**PART 6: Planning Applications for Decision****Item 6.1****1 SUMMARY OF APPLICATION DETAILS**

Ref: 20/01436/FUL  
Location: Land R/O 279-289 Selsdon Road, South Croydon, CR2 6PS  
Ward: South Croydon  
Description: Demolition of existing garages and erection of a three storey residential development of 8 flats, together with parking, landscaping improvements and other associated works.  
Drawing Nos: 0001,0003, 0005, 0006, 0007, 0008, 0030 Rev B, 0100 Rev E, 0101 Rev A, 0102 Rev A, 0103 Rev A, 0151, 0152 Rev A, 0171 Rev B, 0172 Rev B, 0173 Rev B, 0174 Rev B.  
Applicant: Brick by Brick Croydon Ltd  
Agent: Carter Jonas  
Case Officer: Helen Furnell

**2 SCHEME AMENDMENTS**

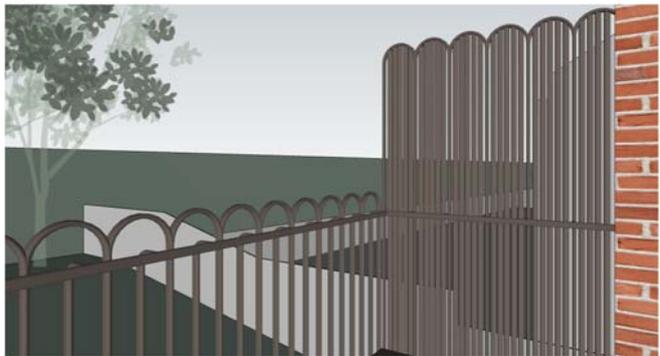
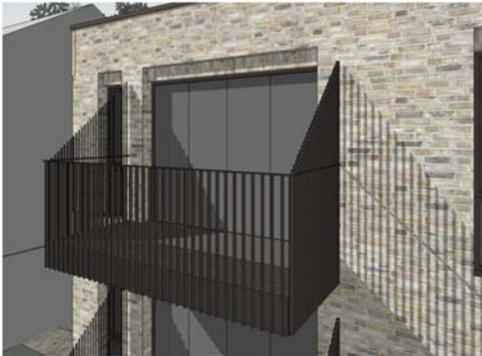
4.1 The applicant has undertaken a review of the surrounding context to the building and has made some minor amendments to the façade design of the building. The changes are as follows:

- The façade material has been changed to a red brick to reference Sunnynook Gardens, but the material will have tones of brown to relate it to the building on the front of the site.
- The existing building is referenced by horizontal soldier course banding on each floor level.
- The façade would be symmetrical with generous vertical openings to reference the proportions of the Victorian terraces on Selsdon Road.
- At ground floor level, protruding brick headers will reference the ground datum, which references Sunnynook Gardens as buildings in that road have an articulated base to the buildings.
- The entrances to the buildings are expressed as arches to also reference features found at Sunnynook Gardens.

- 4.2 The overall level of detailing in this proposed design is considered acceptable and the references to other features in the locality is considered to be an improvement to the design of the building. Officers are supportive of the horizontal banding, the vertical openings, the protruding brick headers and the revision to the brick colour. The approach that references the brick arches found in Sunny Nook Gardens is supported in principle, however, the relationship between the arches and the floor slab behind has not been fully resolved. Further detail can be secured by the imposition of a planning condition requiring the submission of further detailing.
- 4.3 The Committee raised concern with the balcony design and the privacy aspects of the balcony screening. In response to this, the design of the balcony screening has been

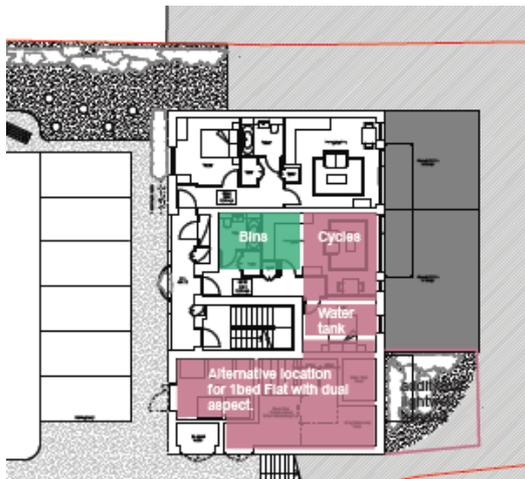
amended from a simple railing with a graduated angle at the side, to the use of arch features on the top of the balustrade railings (reflecting the changes on the front elevation) and the use of a full height screen on the side of the balcony.

- 4.4 This change is considered acceptable and reflects features found in the locality of the site. Refinement of the balcony balustrade and screening detail can be controlled by the imposition of a planning condition.

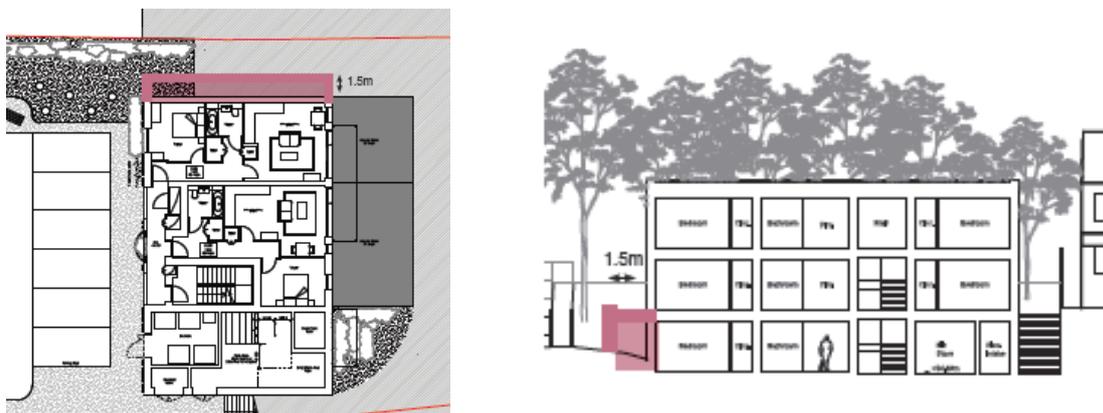
4.11 In order to provide an M4(3) unit to the scheme, additional floorspace would need to be created. Additional information has been submitted to show how this could be accommodated.

4.12 It would require an additional 1.5m strip to the north of the building to ensure that there is sufficient manoeuvring space for a wheelchair. This would bring the development closer to properties in Sunnynook Gardens, would narrow the access to the rear amenity space and would also have a negative impact on the design of the building.

4.13 There is also a financial dimension to accommodating a M4(3) unit within the development. The applicant has explored options to incorporate an M4(3) unit, including the additional size of the building outlined in the diagrams above and also by combining the two ground floor units to make a larger M4(3) unit. In both options, the financial impact of the changes would render the scheme unviable (and this has been

demonstrated in revisions to the Financial Viability Assessment). Officers are satisfied that an M4(3) unit cannot be accommodated within this proposed development.

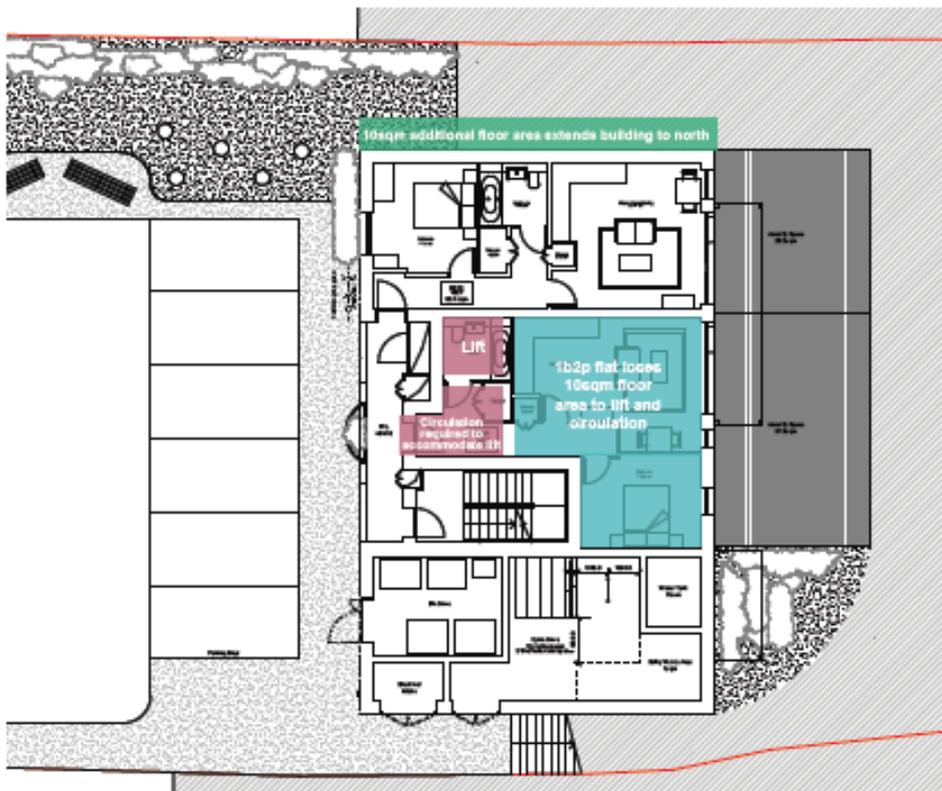
4.14 Additional information has been submitted to provide justification as to why no lift has been provided. The supporting text to policy D7 (accessible housing), of the 'Intend to Publish' London Plan 2019 sets out that in exceptional circumstances, the provision of a lift to dwelling entrances may not be achievable and that in blocks of four storeys or less it may be necessary to be flexible. Small scale infill developments, of which the development proposed is an example, are one of the types of development that the flexible approach can be applied to.

4.15 In this case, there are two elements to the additional justification: financial and design implications. Firstly, the financial implication. There is an additional cost of £65,000 in order to provide a lift to the building. This amount would have a significant impact on the viability of the scheme, resulting in the scheme being unviable. Secondly, there are the design and layout implications of the provision of a lift. Layout plans have been submitted which show that if a lift was to be incorporated within the building, this would require an increase in the footprint of the building.

4.16 The footprint of the building would need to increase by 10 sqm to accommodate a lift and this would require the building to move 1m closer to the northern boundary of the site. This would bring the proposed building in closer proximity to properties in Sunnynook Gardens. This would have an increased impact on the amenity of occupiers of these properties by way of increased impact on outlook and would increase overshadowing to the rear of these properties. On balance it is considered that a flexible approach to the provision of a lift is appropriate in this case as the incorporation of a lift into this development with a larger building footprint would have a detrimental impact on the occupiers of adjoining properties. On this basis, the development is proposed without a lift and this approach is acceptable to officers.
